Access Compliance Report Public Rights-of-Way (Curb Ramps)

Intersection ID: 18381 Main Street: BATHURST DR **Cross Street: WYALONG DR** Location: NW ADA ID: DBDD588F710E Ramp Type: PerpDiag Initial Pass/Fail: Fail **Overall Compliance: No Severity Score:** 12.5

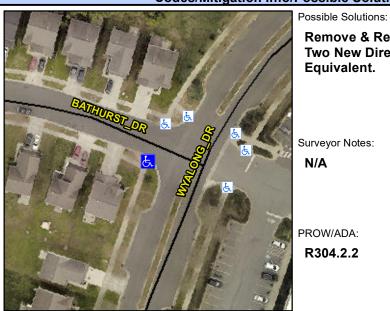
R304.2.2

Field Measurements/Component Compnance						
Compliance Description			Data	Compliance Description		Data
	N/A	Ramp Length (in)	72.0	No	Ramp Slope (%)	10.8
	Yes	Ramp Width (in)	70.5	Yes	Ramp XSlope (%)	1.7
	N/A	Flare Type LT	N/A	N/A	Flare Type RT	N/A
	N/A	Flare Slope LT (%)	N/A	N/A	Flare Slope RT (%)	N/A
	N/A	Flare Traversable LT?	N/A	N/A	Flare Traversable RT?	N/A
	N/A	Landing Length (in)	N/A	N/A	DWS Provided?	N/A
	N/A	Landing Width (in)	N/A	N/A	DWS Contrast?	N/A
	N/A	Landing Slope (%)	N/A	N/A	DWS Length (in)	N/A
	N/A	Landing X Slope (%)	N/A	N/A	DWS Full Width?	N/A
	N/A	Landing Curb? (Y/N)	N/A	N/A	DWS Offset (in)	N/A
	N/A	Shared Landing?	N/A			
	N/A	Gutter Ponding?	N/A	N/A	Gutter Slope (%)	N/A
	N/A	Gutter Lip Ht (in)	N/A	N/A	Gutter X Slope (%)	N/A
	N/A	Painted X Walk1?	No	N/A	Painted X Walk2?	No
		X Walk 1 Direction	To SE		X Walk 2 Direction	To NE
	N/A	X Walk 1 Width (in)	N/A	N/A	X Walk 2 Width (in)	N/A
		X Walk 1 Slope (%)	3.7		X Walk 2 Slope (%)	2.3

Remove & Replace Curb Ramp With Two New Directional Ramps or
